Notice of Energy Code Objections

Applicant:	Date: 3/2/17
WIEPKE DAVID JANSEN	Job Application #: 121328205 DOC# 10
AAI ARCHITECTS, P.C.	Application Type: ASHRAE 90.1/ 2007 - NB
14 WALL STREET NEW YORK NY 10005	Premises Address: 217 West 57 th Street
NZIGOMANIS@ADAMSON-ASSOCIATES.COM	Zoning District:
416-967-1500	Block: x Lot: x
NYC Department of Buildings Examiner: Bruce R. Kahle, AIA bkahle@buildings.nyc.gov

REVIEW OF 04-25-18 EN Set for ECC AUDIT : Open Issues. BUBBLED COMMENTS REMAIN UNRESOLVED. 015

DATE: 04/04/14
PROJECT No: Y130747-000
DRAWN: JWPW
CHK: EA
SCALE: 1/8" = 1'-0"
DWG No:
E-113.01
DOB PAGE No: 15 of 127
DOB EMPLOYEE STAMP:
DOB S-SCAN:

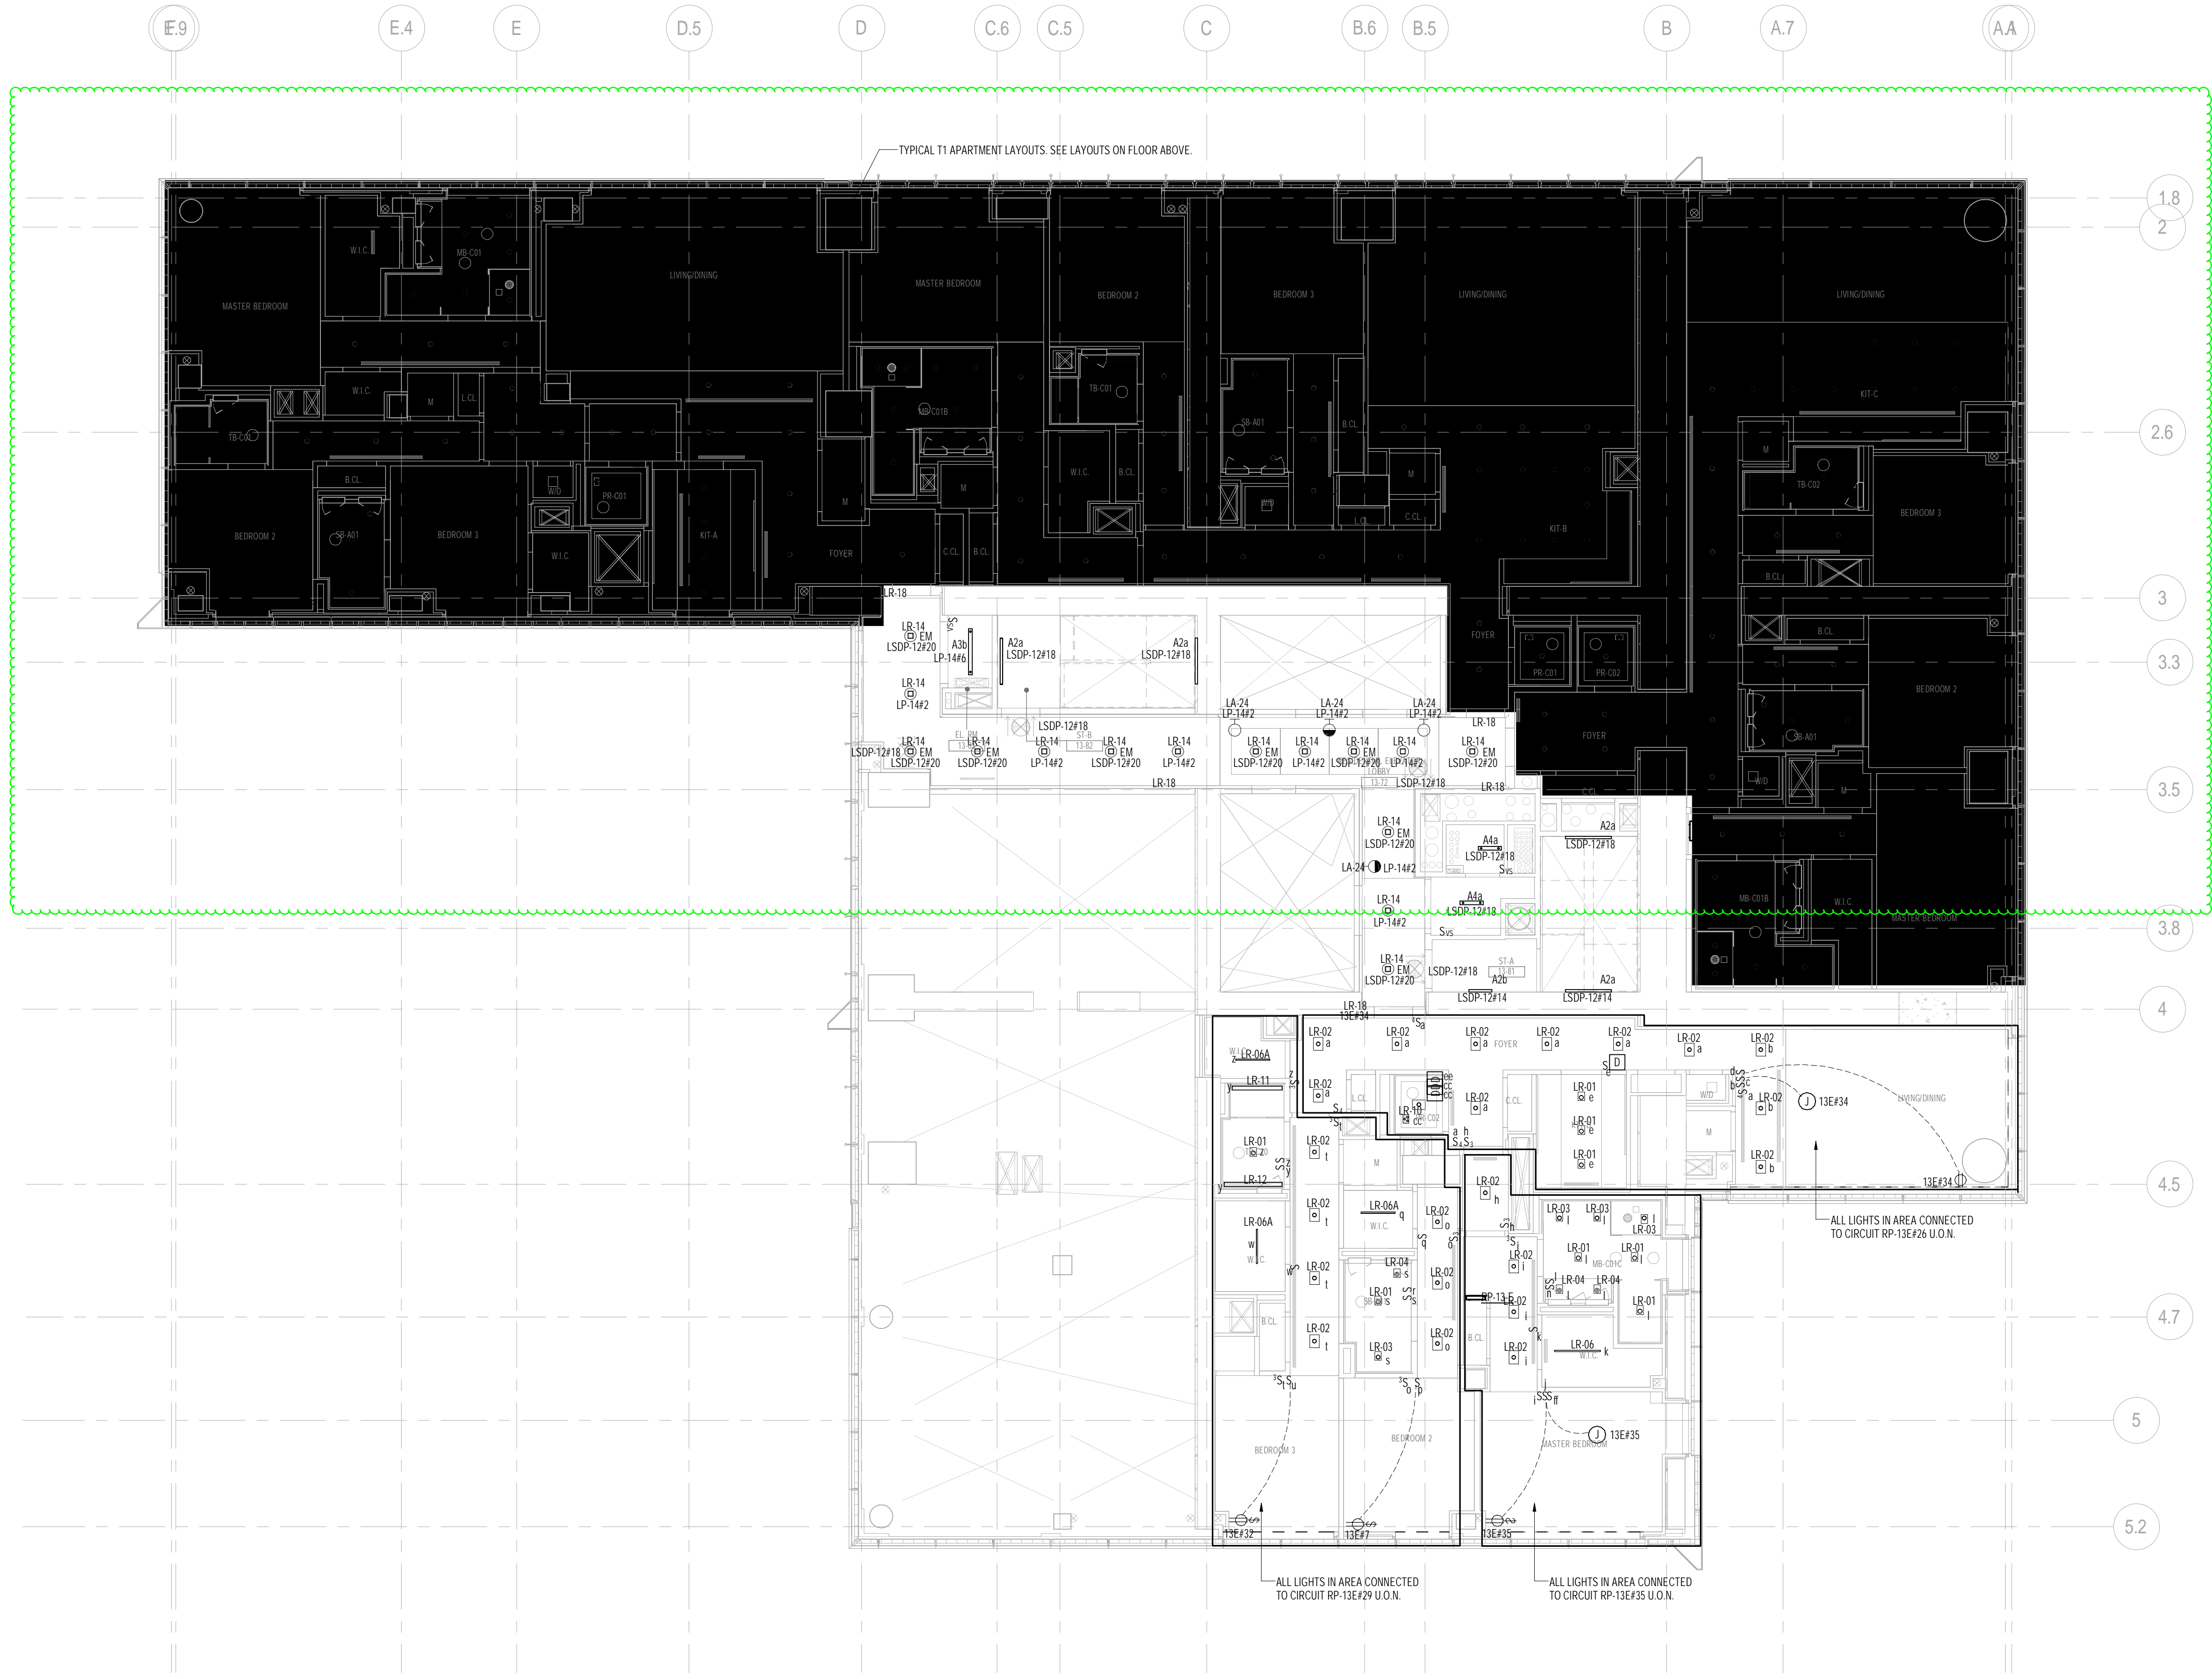
9.4.1	Provide ALL mandatory Controls and Coordinate Room labels with LPDS per Energy Model	Comment on E-100.01, E-101.01 & E 113.01	<i>Comments on E-100.01, E-101.01 & E-605</i>

19)		9.4.1.2	Control devices to independently control general lighting within is missing.	Comment on E 113.01 & E-121.00	<i>Comments on E-100.01, E-101.01 & E-121.00</i>

20)		9.4.1.3	Drawings do not indicate photosensor, time or astronomical controls for exterior lighting.	Comment on E 113.01	<i>Comments on E-100.01, E-101.01 & E-121.00</i>

SEAL & SIGNATURE: [Signature] DATE: 08/06/15
PROJECT No: Y130747-000
DRAWN: PW REV: 11
CHK: EA
SCALE: 1/8" = 1'-0"
DWG No: **E-121.00**
DOB PAGE No: 22 of 127

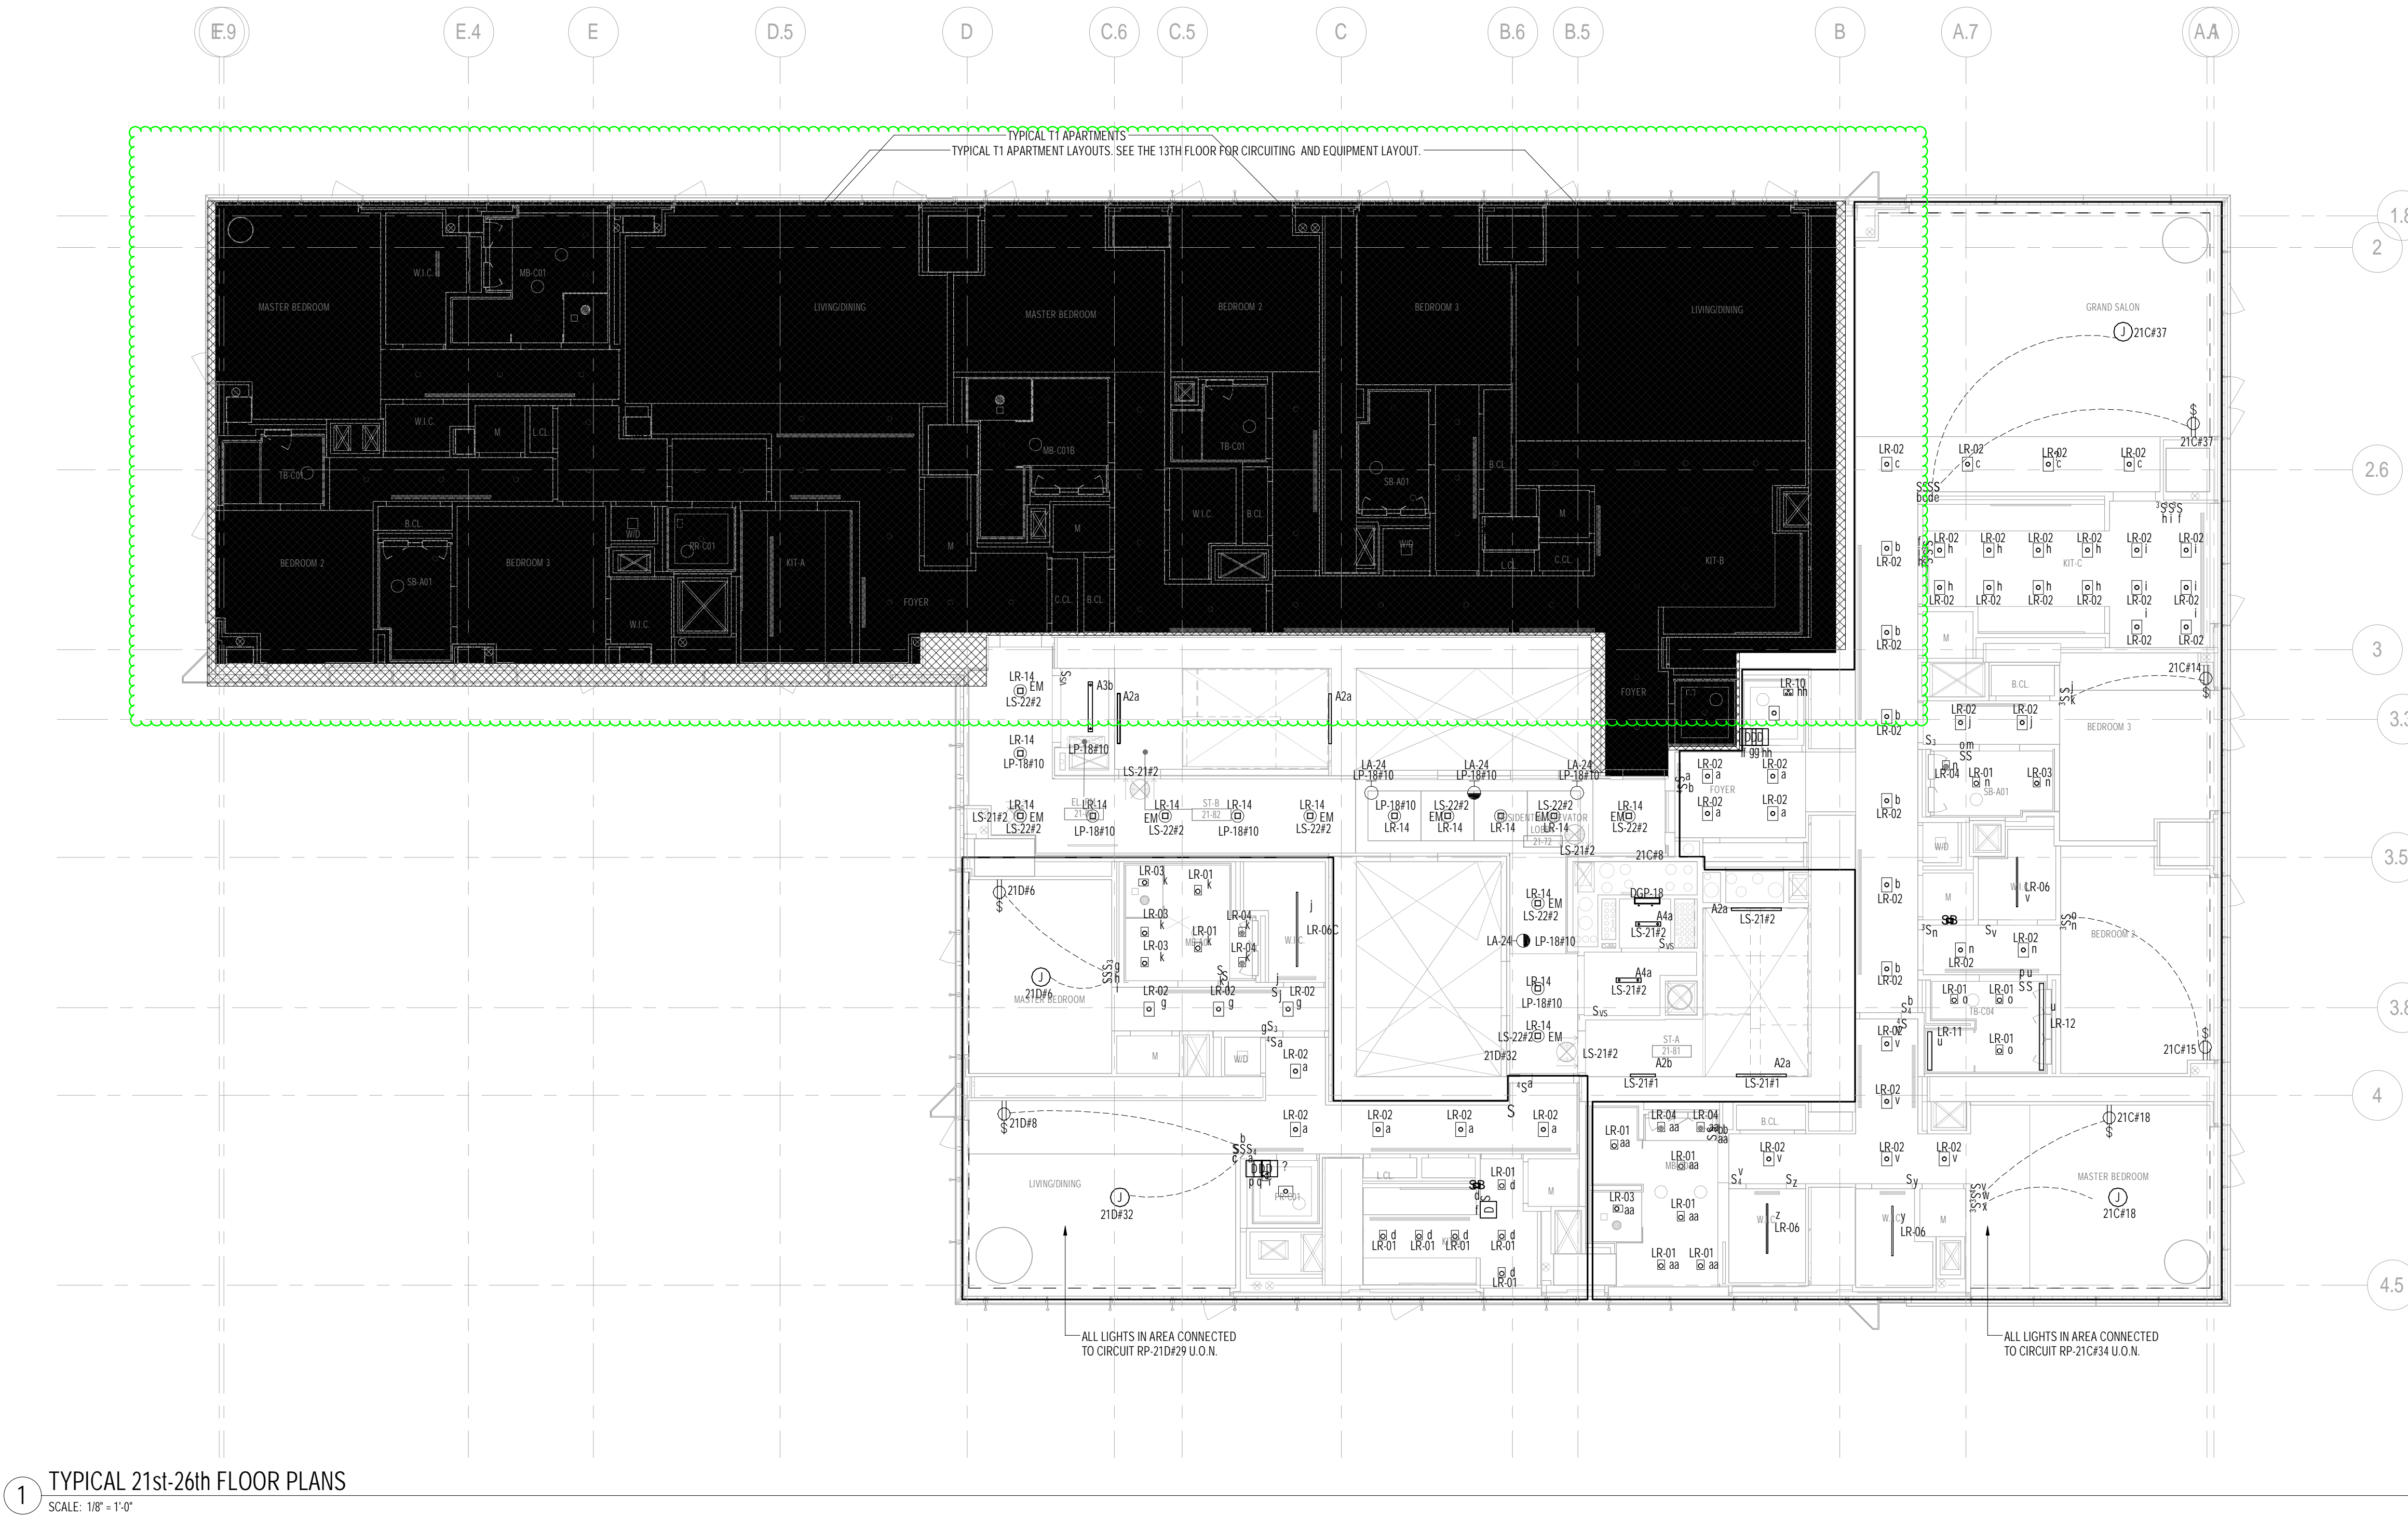
21)		9.4.5	Compliance with exterior lighting power allowance (Watts per square foot) as per Table 9.4.5 not shown.	Comment on E-100.01	<i>Comments on E-100.01, E-101.01 & E-121.00</i>
